PLANNING DEPARTMENT – Development Review Services

December 22, 2015

**RE: Generations at West Mesa
Grading & Drainage Plan
Engineer's Stamp Date 12-22-2015 (File: K11D084)**

GRADING &
DRAINAGE PLAN

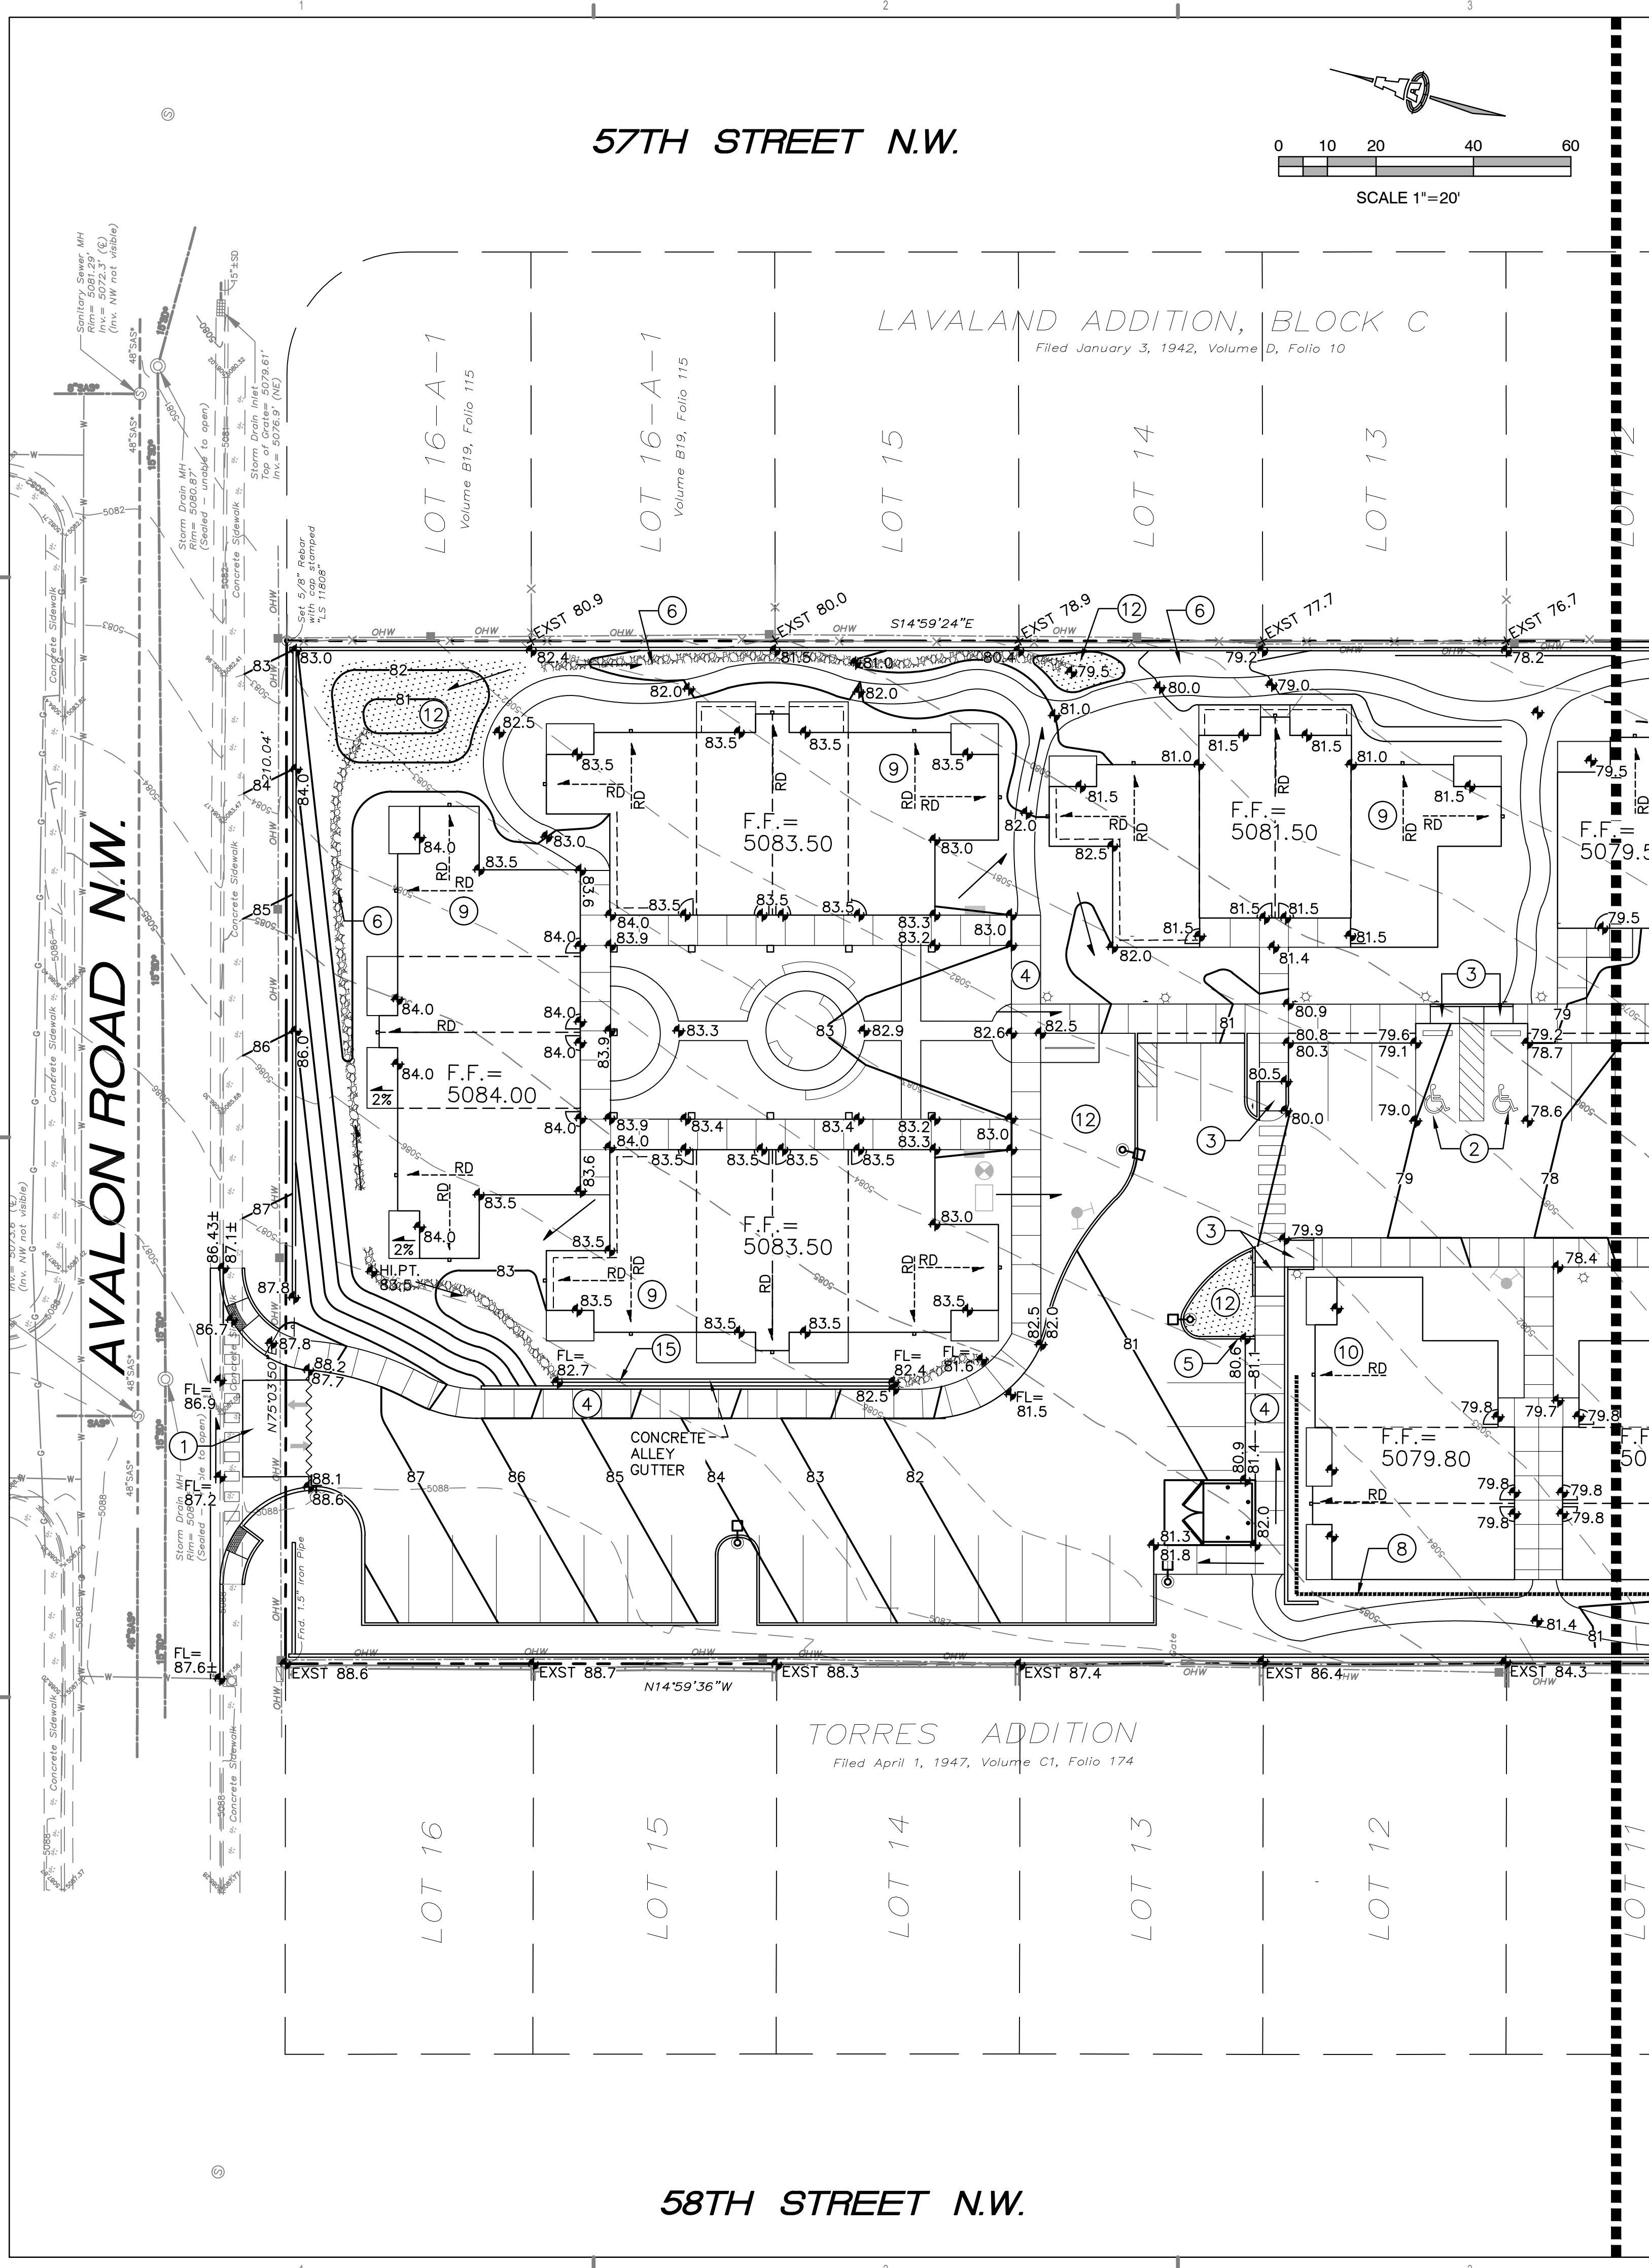
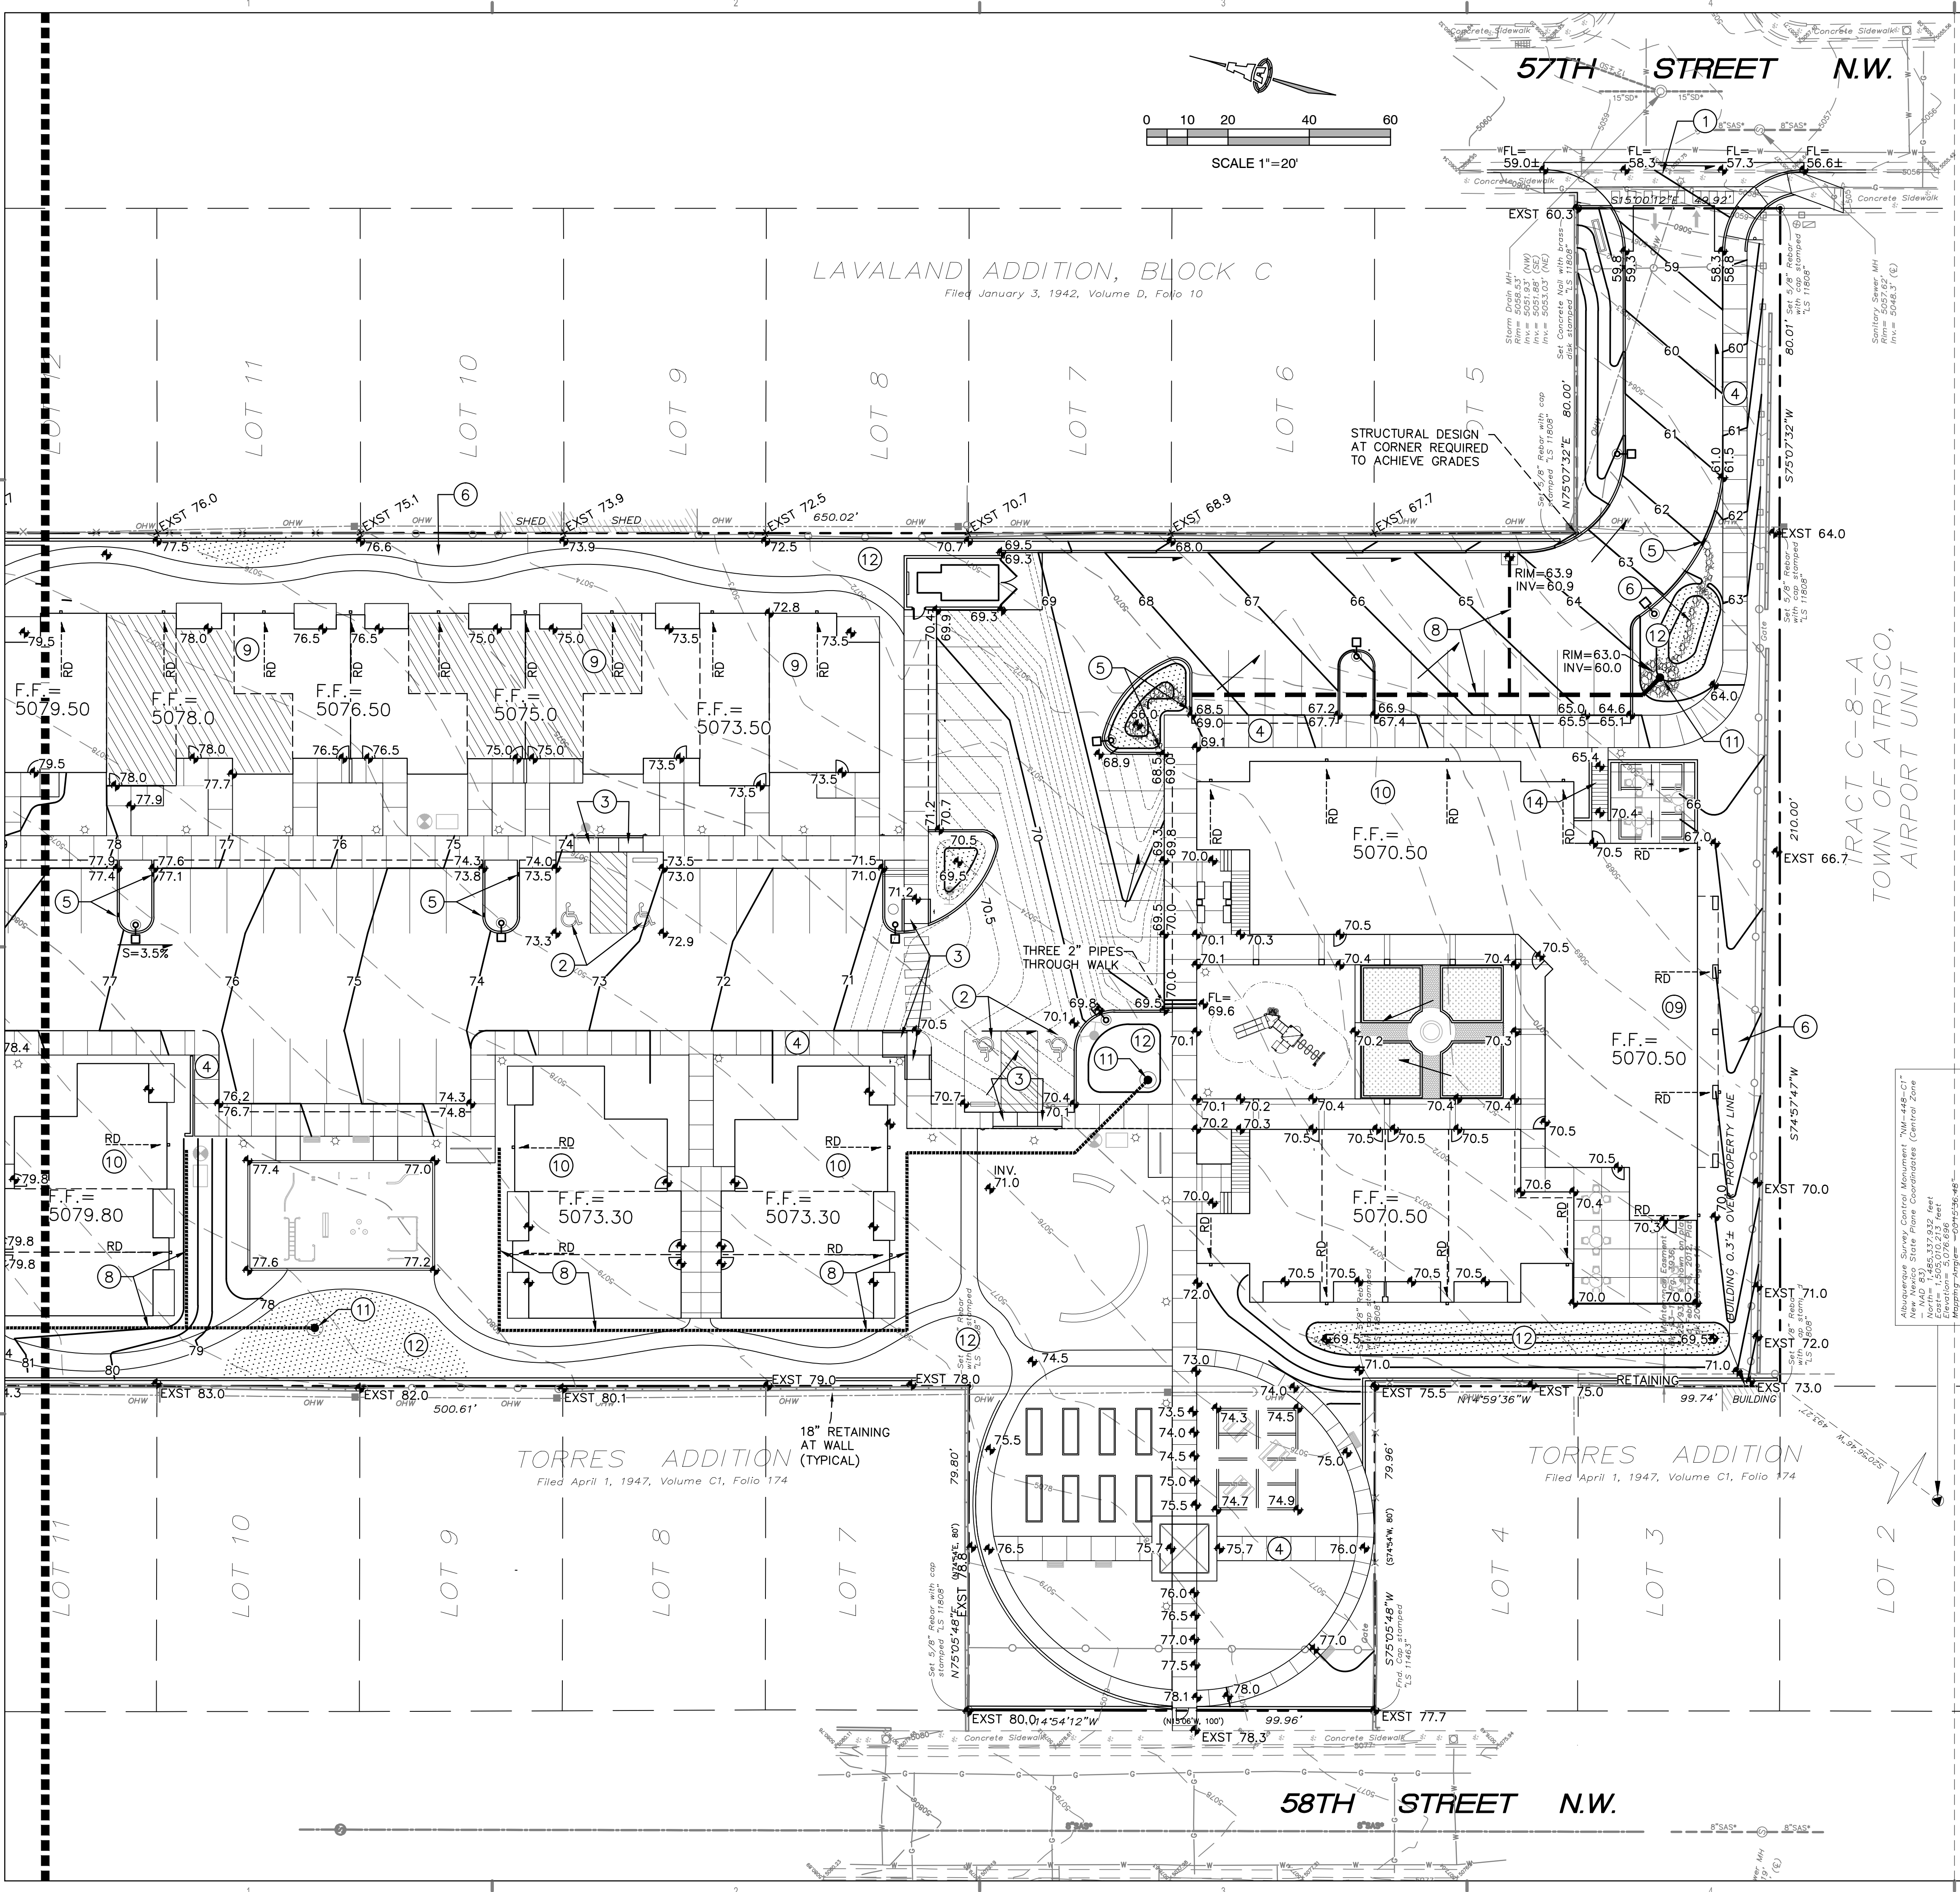
1. Since you are opting to discharge into 57th Street, provide street capacity calculations.
2. Show retaining wall locations, with T.O.W. and B.O.W. elevations.
3. Note any existing walls along boundaries
4. North side of site: provide SW culvert beyond alley gutter
5. Along East and West side of site, provide positive flow path. Provide a section and adjust sidewalk to allow for flow path.
6. Provide a curb cut so swale along eastern edge discharges to driveway
7. Call out inlet on east side of driveway
8. South side of site: provide SW culvert so discharge enters first flush pond
